OAKSTONE SUBDIVISION

APPLICATION NUMBER 14 DATE May 5, 2005

APPLICANT Oakstone Subdivision

REQUEST Subdivision

DETAIL SITE PLAN

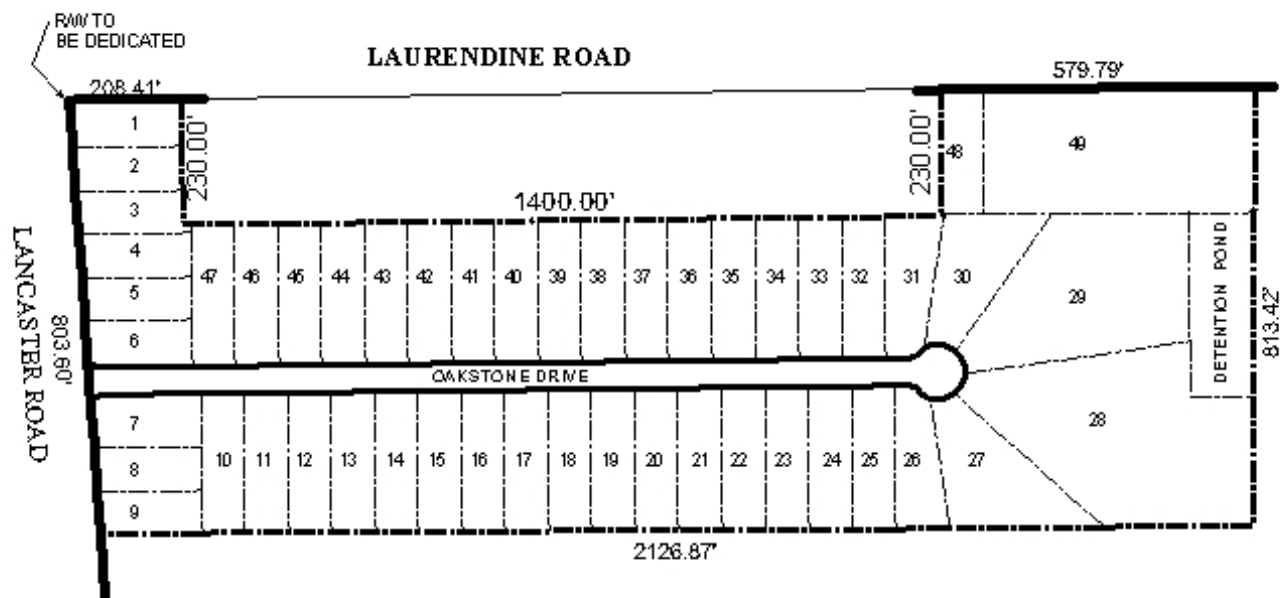
The site fronts onto Lancaster Road and Laurendine Road. Lancaster Road is a minor street, and the existing right-of-way meets the minimum width requirements for minor streets. Laurendine Road, with an existing right-of-way of 80 feet, is a proposed major street, and as such its right-of-way should be 100-feet wide according to the Major Street Plan. Therefore, the dedication of an additional 10-feet should be required along the site's Laurendine Road frontage.

As Laurendine Road is a proposed major street, access management is a concern. The subdivision, as currently designed, depicts lots 1, 48 and 49 having frontage on Laurendine Road. Lot 1 also fronts Lancaster Road, thus it should be restricted to having access only onto Lancaster Road in order to prevent an additional curb cut onto Laurendine Road. Lots 48 and 49 should also be limited in their access to Laurendine Road; lot 48 should be permitted one curb cut onto Laurendine Road, while lot 49, due to its 500-foot \pm frontage on Laurendine Road, should be limited to a maximum of two curb cuts. The size, location and number of all proposed curb cuts onto Lancaster and Laurendine Road must be reviewed and approved by the Mobile County Engineering Department.

The proposed subdivision will have 11 lots that have direct access to either Lancaster or Laurendine Roads, as well as 38 lots that will only have access to a proposed cul-de-sac. The cul-de-sac, Oakstone Drive, is approximately 1,600 feet long. According to Section V.B.6. of the Subdivision Regulations, "*closed-end streets (cul-de-sacs) shall not be longer than 600 feet...*" Long cul-de-sacs present a potential emergency access safety hazard, and it appears that the subdivision could be reconfigured to continue the proposed Oakstone Drive to Laurendine Road, eliminating the cul-de-sac configuration. Reconfiguration of the subdivision to continue Oakstone Drive to Laurendine Road would potentially allow lots 48 and 49 direct access to Oakstone Drive instead of Laurendine Road. The applicant should also consider the need for traffic calming devices for Oakstone Drive.

The 25-foot minimum building setback line from the right-of-way is not shown but would be required on the Final Plat, if approved.

The eastern portion of the site appears to be within the FEMA designated “100-year” floodplain of Muddy Creek, and wetlands associated with the creek may occur on a portion of the site. According to County Engineering staff, it appears that no detailed floodplain or floodway determination has been made for this site, therefore, a study may be required. The presence of wetlands and floodplains indicate that the area may be environmentally sensitive; therefore, the approval of all applicable federal, state and local agencies would be required prior to the issuance of any permits.

The plat also shows a detention pond proposed for the eastern side of the subdivision, without any indication of access via easement or dedicated street, and within the FEMA designated 100-year floodplain. Generally speaking, detention ponds located within floodplains do not provide sufficient detention capacity, and the location of such a pond within the floodplain may reduce the capacity of the floodplain, as well as not be in compliance with the Mobile County Flood Damage Prevention Ordinance. Therefore, the applicant should consult with the Mobile County Engineering Department to determine the appropriate location of the proposed detention pond. The applicant should also revise the plat to indicate how the detention pond will be accessed, in conformance with Sections VI.C.3. and VII.B.2.

Finally, the written Legal Description and the drawn plat appear to have numerous errors, including missing or incorrect dimensions, and incorrect or missing bearings. Furthermore, the plat is drawn at a scale of 1-inch equals 150 feet, which is a non-standard engineering scale, and thus is not in conformance with Section IV.A.1.

Based upon the proceeding, the plat is recommended for Holdover for the following reasons: 1) revision of the plat to address cul-de-sac length issues in accordance with Section V.B.6.; 2) revision of the plat to reflect the relocation of the detention pond, if necessary, as approved by County Engineering (if relocation requires significant reconfiguration of lots or roadway, a new application will be required); 3) indication of access to the detention pond, in accordance with Sections VI.C.3. and VII.B.2.; 4) correction of all written and depicted dimensions and bearings in the Legal Description and on the plat; and 5) the provision of a plat drawn to a standard engineering scale.
